# Panel Report

Maribyrnong Planning Scheme

Amendment C125

'Footscray Central Activity Area'

Figure 4 Joseph Road Urban Framework Plan May 2013

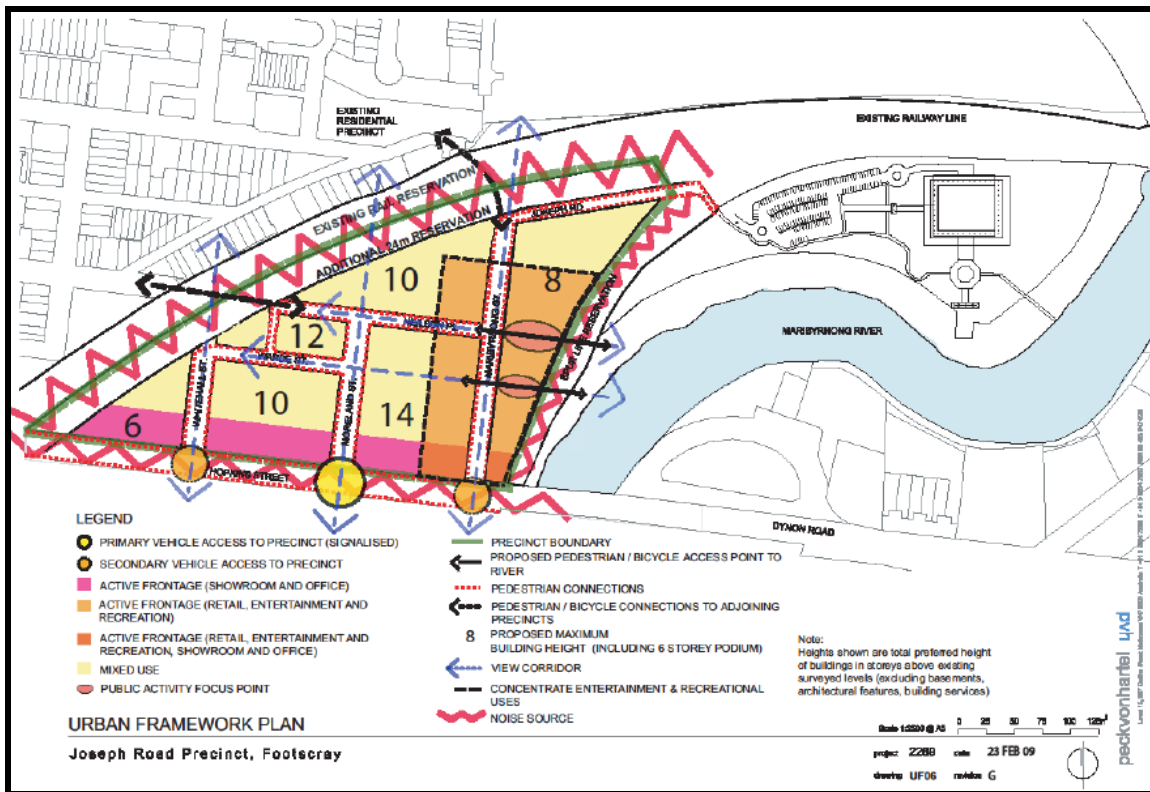
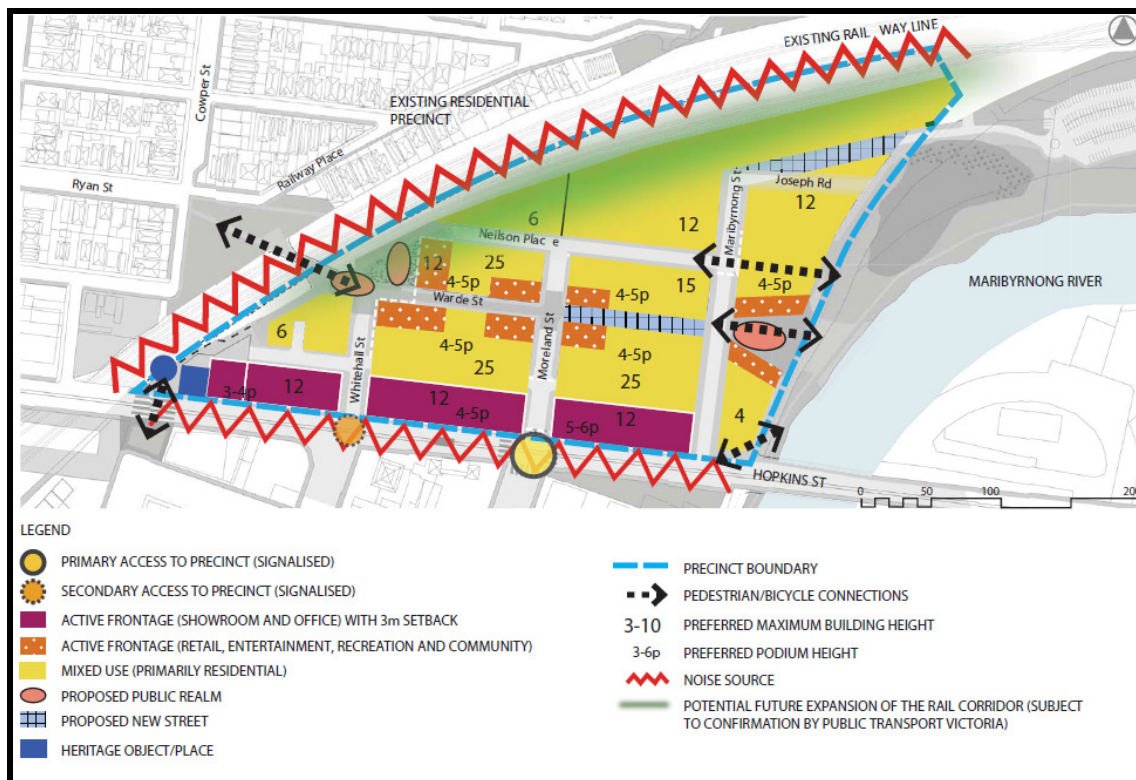
In its submission to the Panel, Council provided a comparison between the *Joseph Road Urban Framework Plan 2009* (Figure 3 - introduced by Amendment C78), the *Joseph Road Urban Framework Plan May 2013* (Figure 4 - Amendment C105) and the *Joseph Road Urban Framework Plan April 2013* (Figure 5 – Amendment C125).

The numbers on each plan represent the discretionary maximum building height in storeys (e.g. 6) or podium height in storeys (e.g. 3-6p).

Figure 10 Precinct 5 – Joseph Road; Map and Precinct Requirements

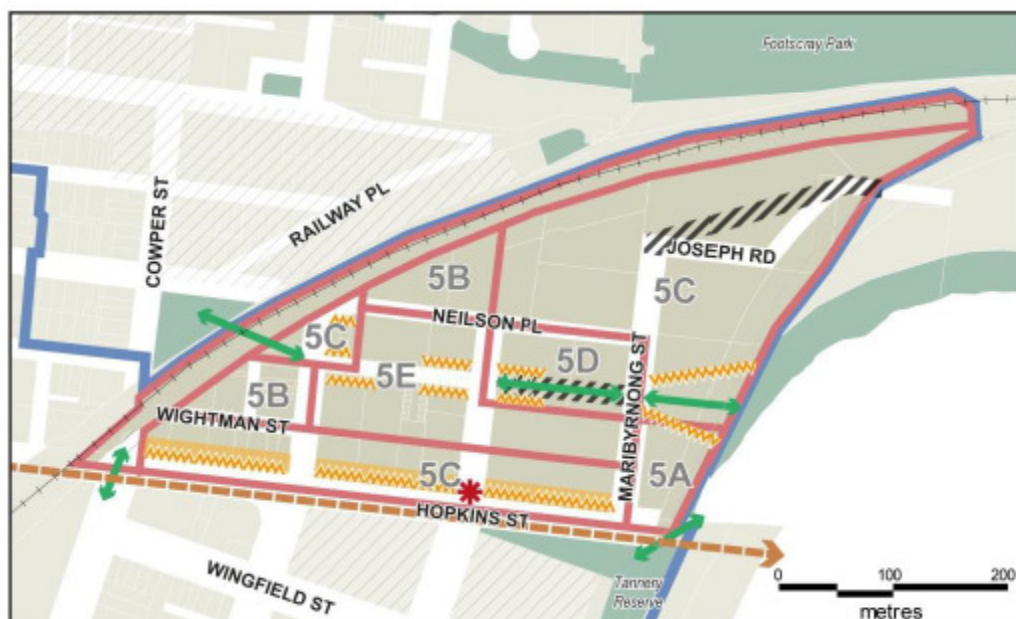
Figure 10 identifies the precinct map identifying sub-precincts and existing features and the related building height and setback table.
